**1 DETAILS OF THE DEVELOPMENT**

Ref: 23/04171/PRE  
Location: Spurgeon's College, 189 South Norwood Hill, South Norwood, London, SE25 6DJ  
Ward: Thornton Heath  
Description: Mixed use development for redevelopment of the site to provide an extension to the locally listed building and new education building and basement to provide purpose built higher education facilities and extensions to the existing locally listed building and 42 family homes  
Applicant: Spurgeon's College and London Square  
Agent: Richard Quelch  
Case Officer: Katy Marks

Figure 11: Tree removal plan (based on scheme from Oct 2023) showing removal of 80 trees.

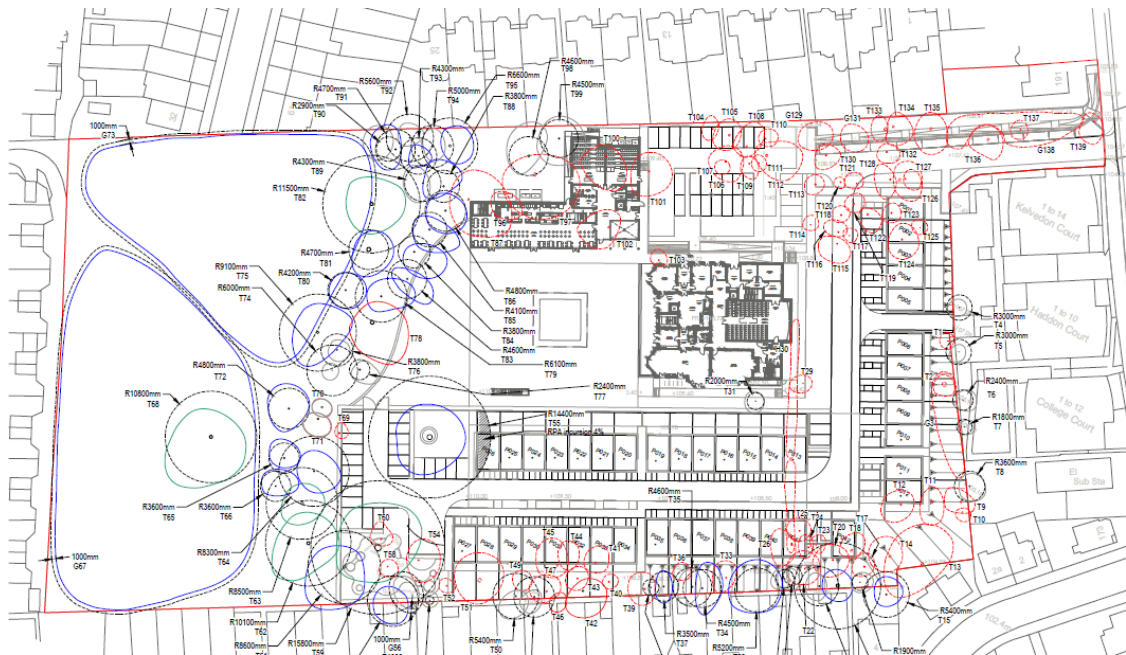
6.26 Officers have an overarching concern with regards to the number of trees to be removed; in addition specific concerns with various parts of the proposal which have been broken down to the different aspects of the scheme: a) tree loss along the access road and car park, b) tree loss and harm caused by the TJ building, c) impact of development upon two of the most prominent high quality trees on the site (a category A Oak Tre (T59) and Horse Chestnut (T55), d) loss of trees and harm to trees along the south-eastern boundary.

Figure 16: sketch of layout to improve the relationship with trees along the boundary

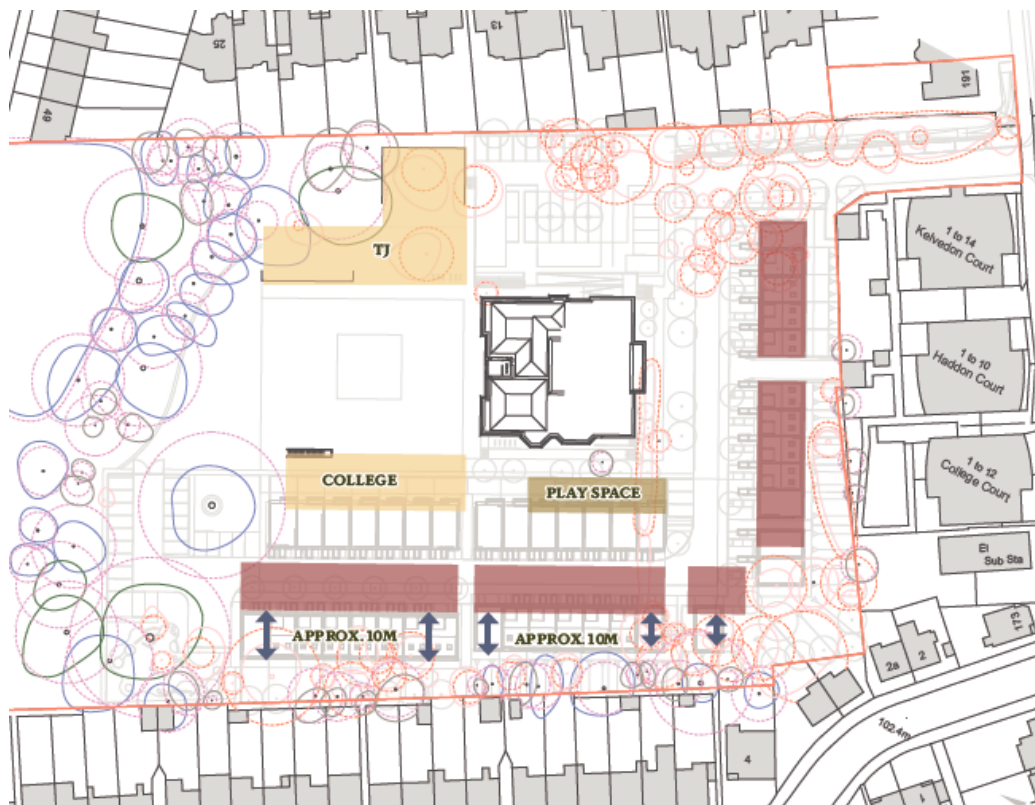
6.32 Officers consider that design changes and potential reduction in the scale of development is required to deal more sensitively with the tree constraints on the site. The applicant has suggested that in order to retain all or more trees along the south-eastern boundary, they would have to move the residential building line approximately 10m further north which would reduce the housing scheme by around 15-16 houses which would not be viable. Officers acknowledge the viability position, but suggest that this or alternatives should be tested further given the positive benefits of retaining trees (and other potential benefits of an alternative approach such as moving some of the education facilities to grade level which might reduce build costs and balance out the viability impact of a reduced number of homes).

Figure 20: Relationship between houses and College

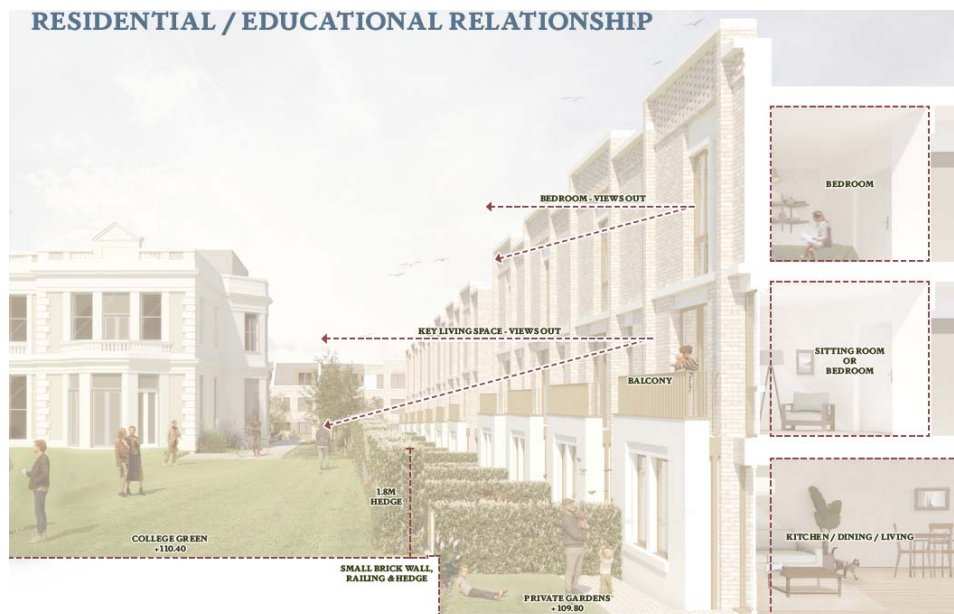
- 6.55 Officers have some reservations with regards to the living conditions for residents of the terrace backing onto the College 'lawn'. The properties will have 5m deep rear gardens with land levels sunken below the level of the College lawn. Further evidence is required to demonstrate how privacy would be maintained for residents, appropriate boundary treatment and how the two uses would interact successfully, especially given the outlook for residents over the 'College Lawn' to which they would not have daily access.

Figure 22: showing overlooking of garden

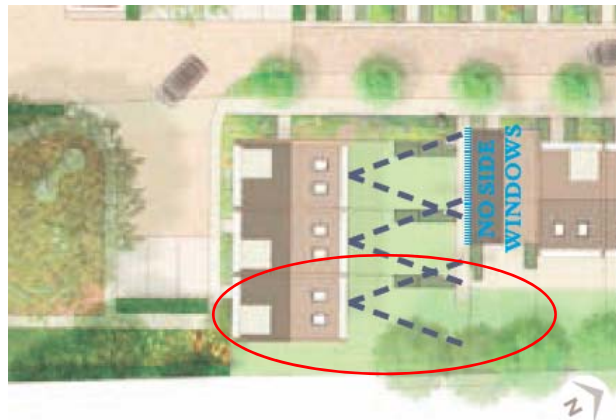
6.57 In addition, a recent change to the plans have introduced a small row of terraces close to the woodland entrance. These would sit at right angles to the remainder of the houses. Local Plan policy DM10.6c states that in order to protect amenity of adjoining occupiers, development should not result in direct overlooking of private outdoor space within 10m perpendicular to the rear elevation of a dwelling. The end property on the terrace would overlook the rear garden of the end property on the main terrace and whilst the garden has been increased from 5m to 7m in depth, the relationship is still considered to give rise to concerns with regards to overlooking.

Figure 23: Distances between development and neighbours

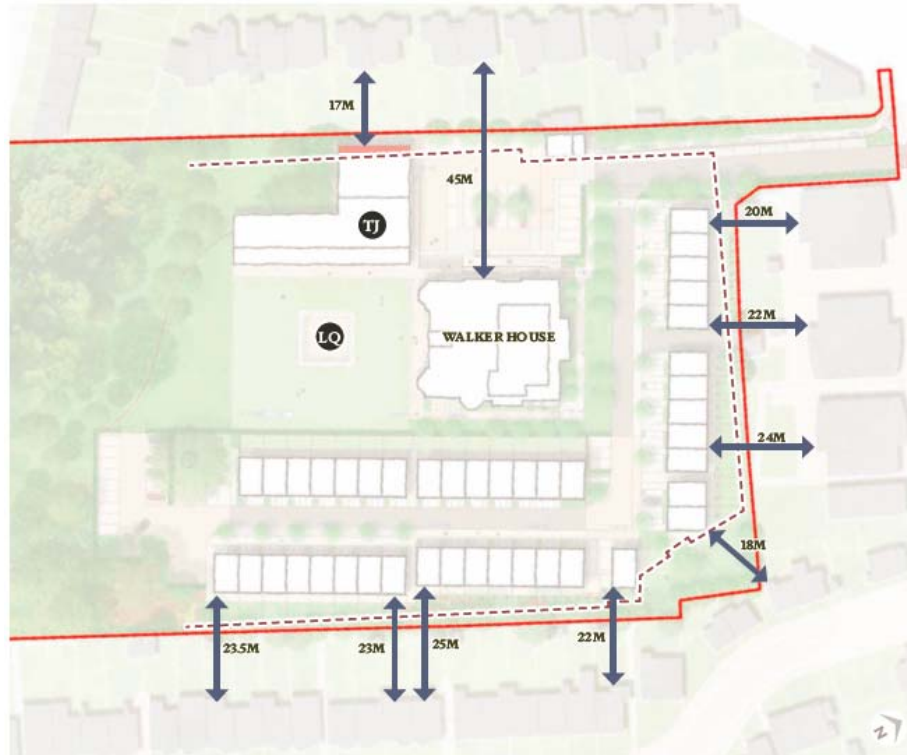
- 6.62 The layout of the development means that it will introduce massing in close proximity to the boundaries of the site with South Norwood Hill, Wharncliffe Gardens and Grange Gardens. Figure 23 provides window to window distances for properties surrounding the site. The properties are 2-3 storey in height and the set on a higher land level. Generally speaking, the distances between the houses and the neighbouring properties is between 18-25m which is generally considered to protect residential amenity of neighbours subject to further details in terms of sections and daylight sunlight analysis. However, the existing tree line along the boundary with Wharncliffe Gardens provides screening for the residential properties and would continue to play an important role given that the footprint of the new houses close to the boundaries of the site. The removal of trees along this boundary (and potential for post-development pressure on remaining trees) is not supported as it would reduce the privacy for these neighbours.

Figure 24: showing the relationship between the TJ building and properties on Grange Gardens

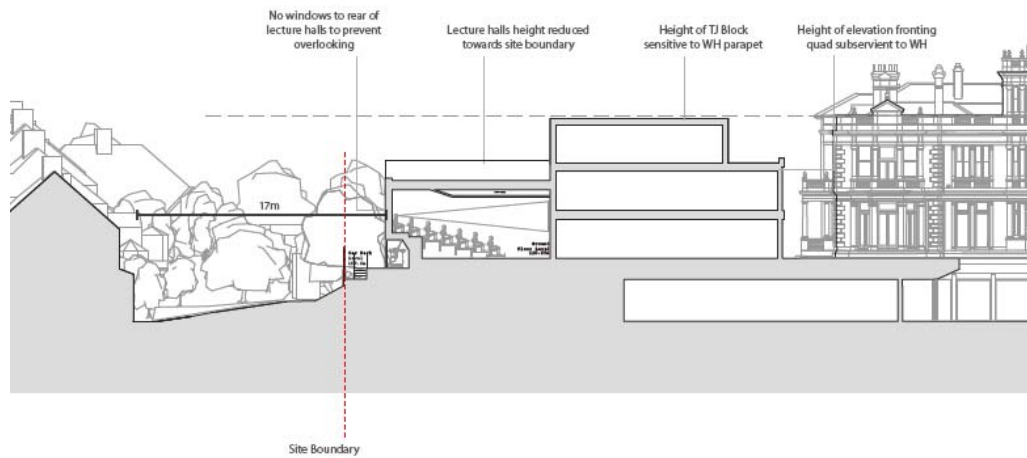
- 6.63 The Thomas Johnson building would step down from 3 storeys at the front down to 2 storeys but the rear elevation would sit in close proximity to the boundary with no. 15 and 17 Grange Gardens. The proposed building would not have any windows in the rear elevation which would protect the privacy of these neighbours. The rear elevation would be roughly 17m from the rear windows of these properties at the closest, however due to land level changes, it would appear as a large blank elevation close to the boundary. The loss of trees in this location and the lower height of neighbouring properties would further affect the residential amenity of neighbours in this location, which is a concern. Further information is required to understand this relationship and design options should be explored to improve the relationship with neighbours in Grange Gardens.
